**AGENDA
PLANNING COMMISSION
116 WEST NEEDLES
BIXBY, OKLAHOMA
November 17, 2014 6:00 PM**

To: Bixby Planning Commission
From: Erik Enyart, AICP, City Planner
Date: Thursday, October 02, 2014
RE: Report and Recommendations for:
PUD 86 – “South Park Self Storage, LLC” – South Park Self Storage, LLC

To: Bixby Planning Commission
From: Erik Enyart, AICP, City Planner
Date: Tuesday, October 07, 2014
RE: Report and Recommendations for:
Preliminary Plat of "Pine Valley Addition" (PUD 12-D)

Exhibit A Overall Site Area Development Area 2 Southpark Self Storage

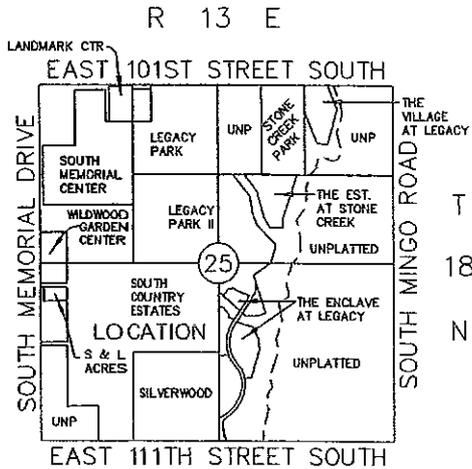
35. PUD Exhibit A1 (the first): Please show proposed fence and/or gate changes proposed as recommended by the Fire Marshal.
36. PUD Exhibit A1 (the first): Please reconcile with title as used in Table of Contents and as used in Exhibit A1 (the second).

37. PUD Exhibit A1 (the first): 16' parking stall depths are not consistent with Bixby Zoning Code standards. Please provide for flexibility in this PUD, propose to restripe (at least the ministorage conversion development area) and revise site plan, or otherwise advise.

38. PUD Exhibit A1 (the first): One (1) ADA-designed parking space may not meet stall depth or access aisle standards of ADA. Please revise in accordance with ADA requirements.

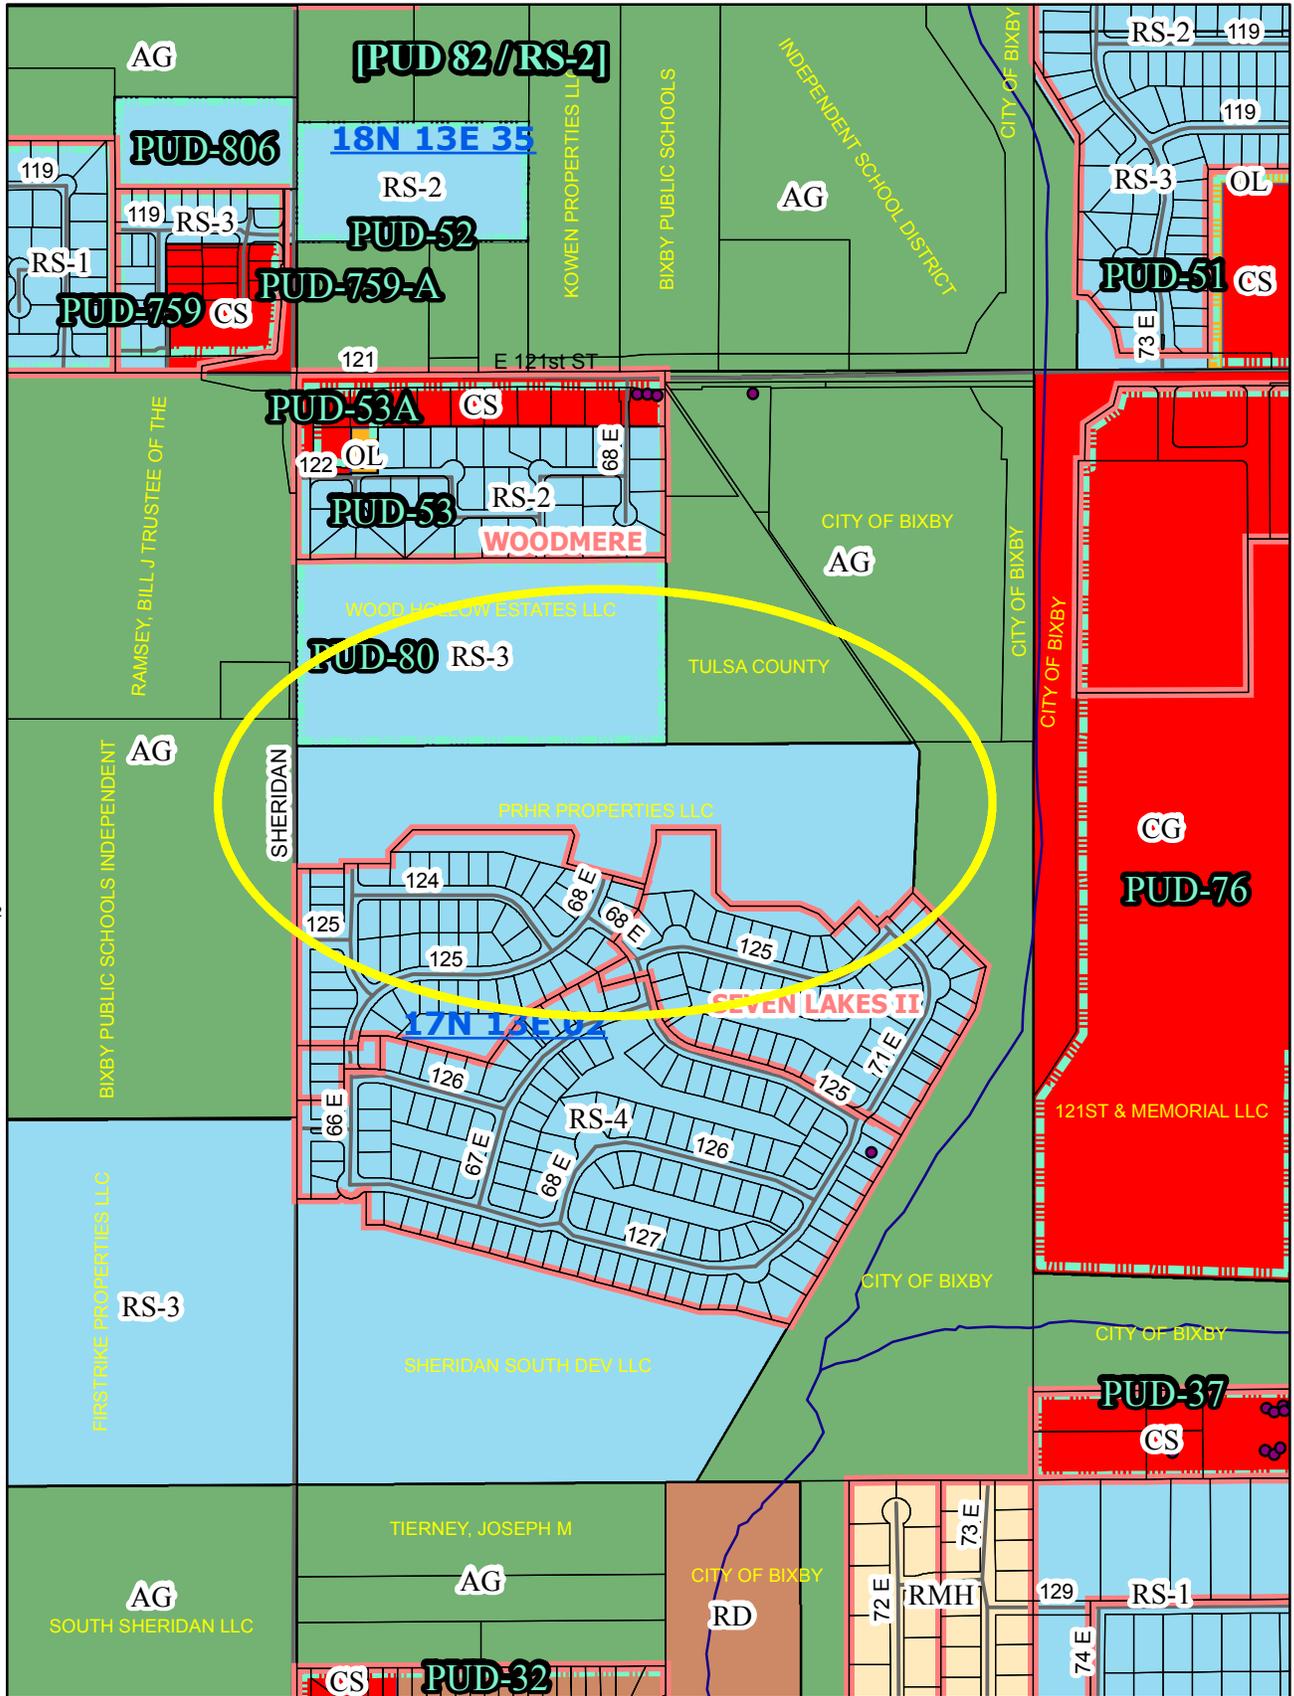
1. Subject to a Modification/Waiver from Subdivision Regulations Section 12-3-4.F, as Lots 11:14, Block 2 and Lot 18, Block 3/4 (and potentially others) appear to exceed the 2:1 maximum depth to width ratio as per SRs Section 12-3-4.F.
2. Subject to a Modification/Waiver from Subdivision Regulations Section 12-3-2.C to provide no stub-out streets to the unplatted tracts abutting to the northeast and east. The

Modification/Waiver was described as justified as it abuts the 'wetland mitigation' area owned by Tulsa County and the Fry Creek Ditch # 2 right-of-way owned by the City of Bixby, neither of which are expected to develop.

3. Subject to a Modification/Waiver from Subdivision Regulations Section 12-3-3.A for utility easements along the perimeters which would not achieve the 17.5' minimum width standards. Such request may be justified by observing most of the instances are mid-block and do not require U/Es, and otherwise by demonstrating where an 11' U/E will be back to back with another 11' in abutting subdivision, resulting in a 22'-wide U/E corridor between the subdivisions. Other justifications may be offered and deemed

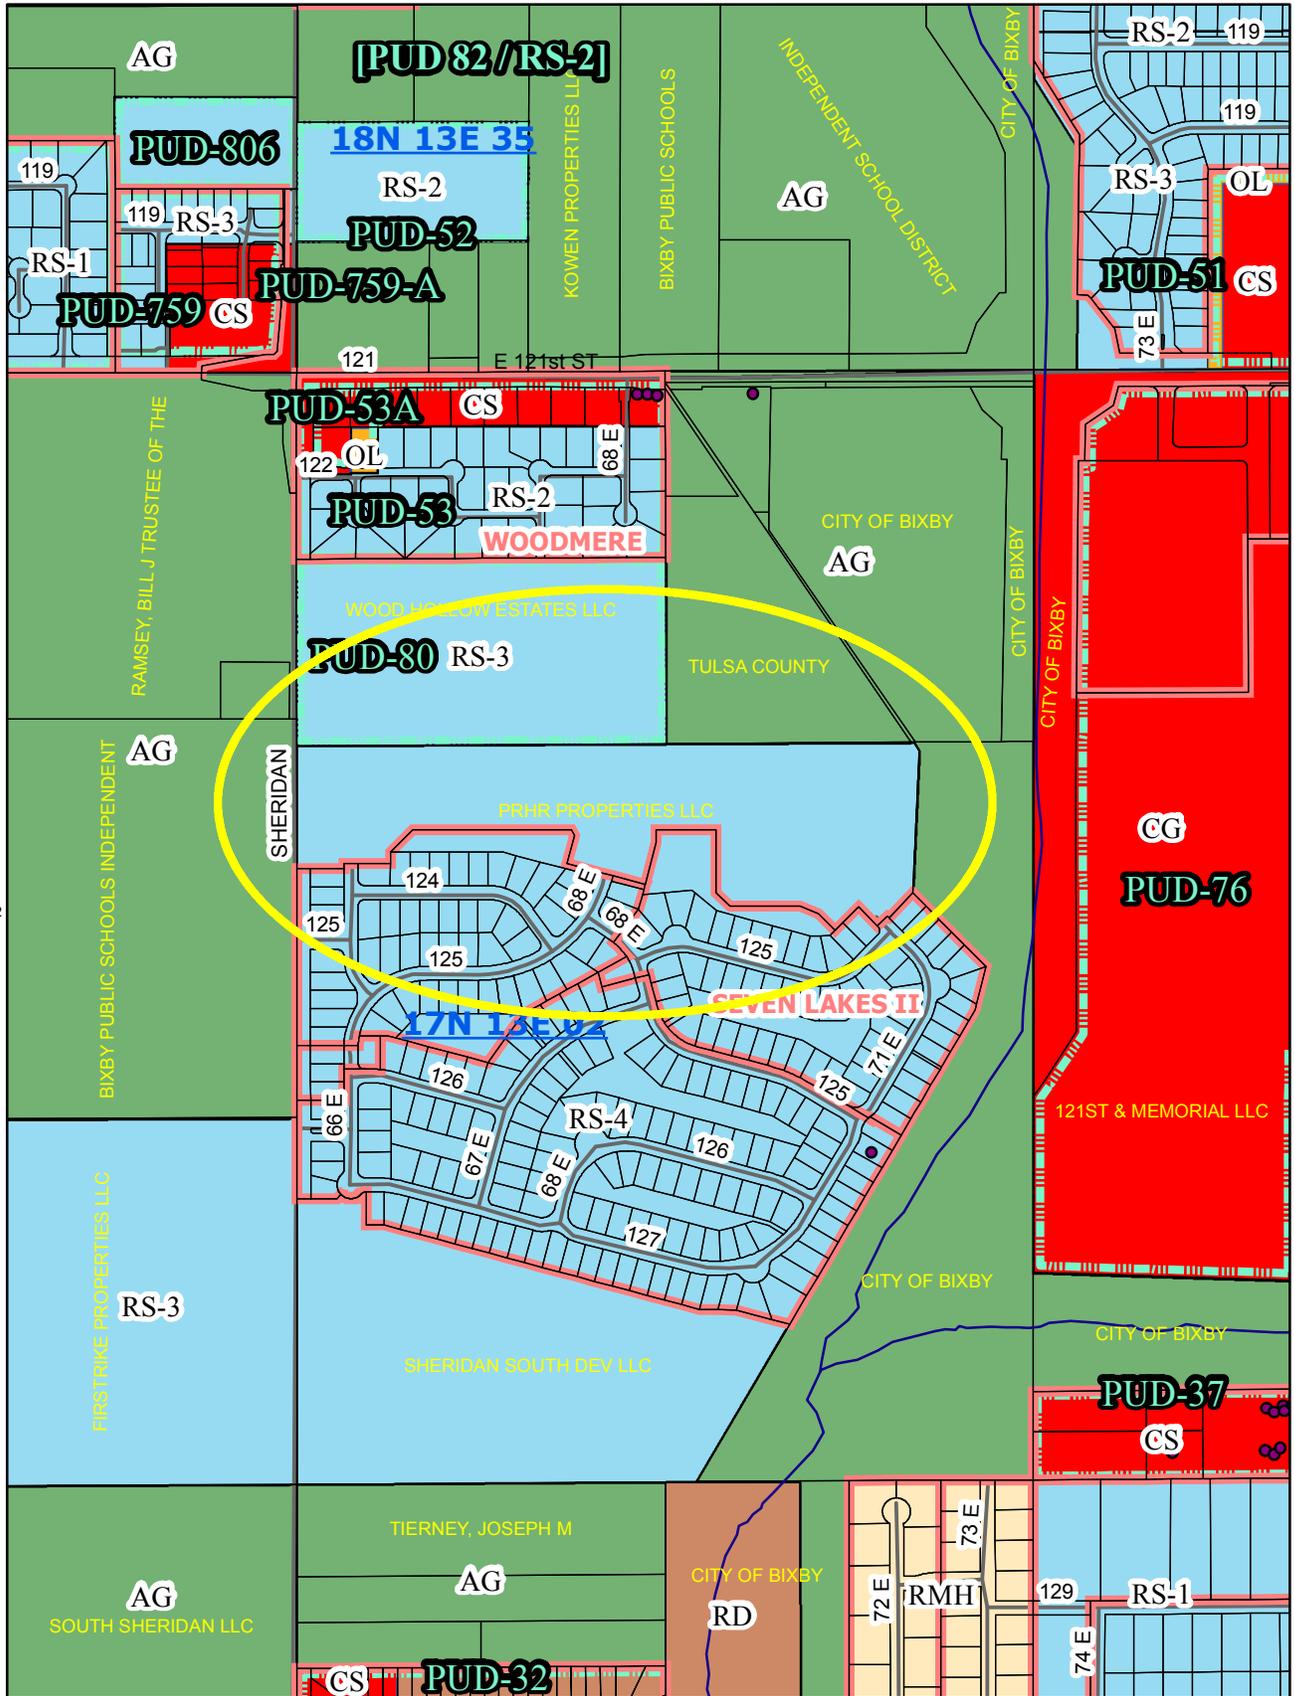
1. Subject to a Modification/Waiver from Subdivision Regulations Section 12-3-4.F, as Lots 11:14, Block 2 and Lot 18, Block 3/4 (and potentially others) appear to exceed the 2:1 maximum depth to width ratio as per SRs Section 12-3-4.F.

2. Subject to a Modification/Waiver from Subdivision Regulations Section 12-3-3.A for utility easements along the perimeters which would not achieve the 17.5' minimum width standards. Such request may be justified by observing most of the instances are mid-block and do not require U/Es, and otherwise by demonstrating where an 11' U/E will be back to back with another 11' in abutting subdivision, resulting in a 22'-wide U/E corridor between the subdivisions. Other justifications may be offered and deemed adequate.
